ACCESSIBILITY COMPLIANCE ASSESSMENT REPORT

*Dept. of Public Health Community Wellness Center, 908 7th
Street, Eureka, CA – CASp Assessment III*

Project #: 1JKI00057.014
Date: 12/22/21

JH 40E

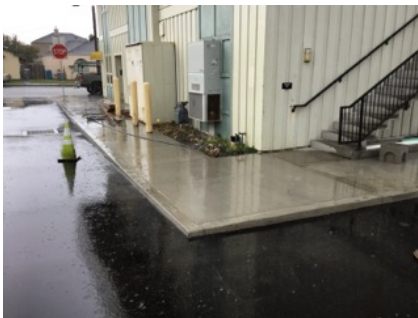
Barrier Description:
No specific accessibility barrier being referenced.

As-Built:
10/21/21: Compliant slopes provided.

szs 64F
First Floor - South Exit Door
CLOSED

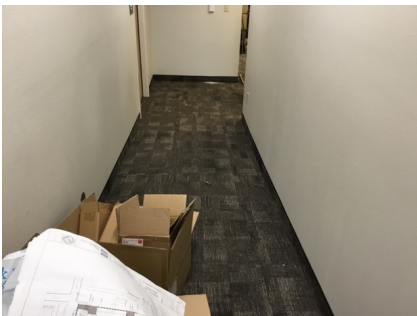
Barrier Description:
Top landing less than 60" x 60" and/or slopes more than 1:48 (2.083%).

As-Built:
10/21/21: TL 60" x 60" provided

Additional Notes:
6.7% slope, Landings BL 72", and TL 60" x 60"

JH 1A

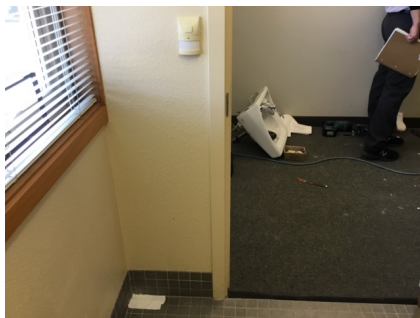
Barrier Description:
Unisex (single-user or family) bathing room does not contain one shower or one shower and one bathtub, one lavatory, and one water closet.

As-Built:
12/13/21: Owner/tenant notes that bathing room couples with applicable code at time of alteration.

Proposed Solution:
Verify compliance with applicable code at time of construction. If room is being altered or is required to be upgraded as part of an alteration project: Remodel to provide an accessible shower, lavatory and water closet. In alterations where it is technically infeasible to comply with Section 11B-603, altering existing toilet or bathing rooms shall not be required where a single unisex (single-user or family) toilet room or bathing room complying with Section 11B-213.2.1 is provided and located in the same area and on the same floor as existing inaccessible toilet or bathing rooms.

SZS 66B
Stairs
CLOSED

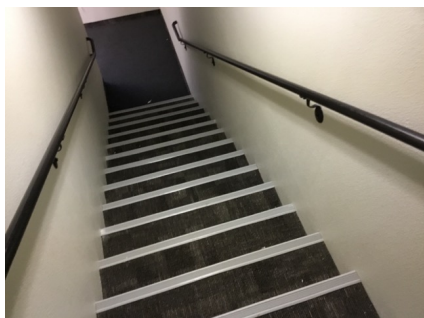
Interior: The upper and lower treads on a flight of stairs lacks a stripe providing clear visual contrast which shall be between 2" and 4" wide placed parallel to, and not more than 1" from, the nose of the step or upper approach and shall extend the full width of the step.

12/13/21: 2" from nosing

Paint 2" to 4" wide contrasting stripe on the upper and lower tread of each flight of stairs.

SZS 66C
Stairs
OPEN

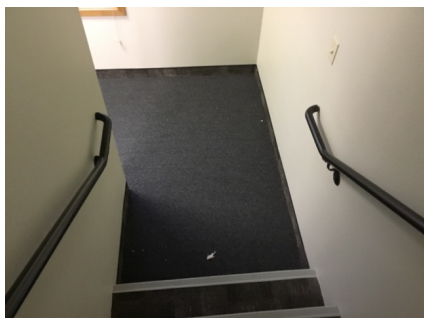
Handrails at the bottom of stairs, do not extend a minimum of one tread depth at the same slope as the stair flight and a minimum of 12" horizontally.

12/13/21: 10" extensions

Modify handrail extensions.

JH 66D
Stairs
OPEN

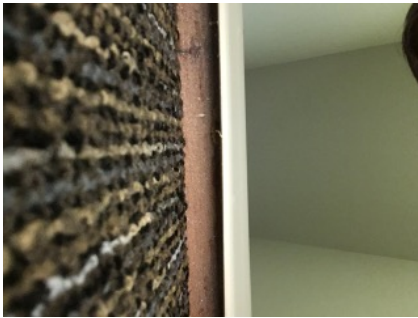
Tread surfaces shall have smooth, rounded, or chamfered exposed edges, and no abrupt edges at the nosing (lower front edge).

12/13/21: 0.5" not beveled

Remodel finish on stairway.
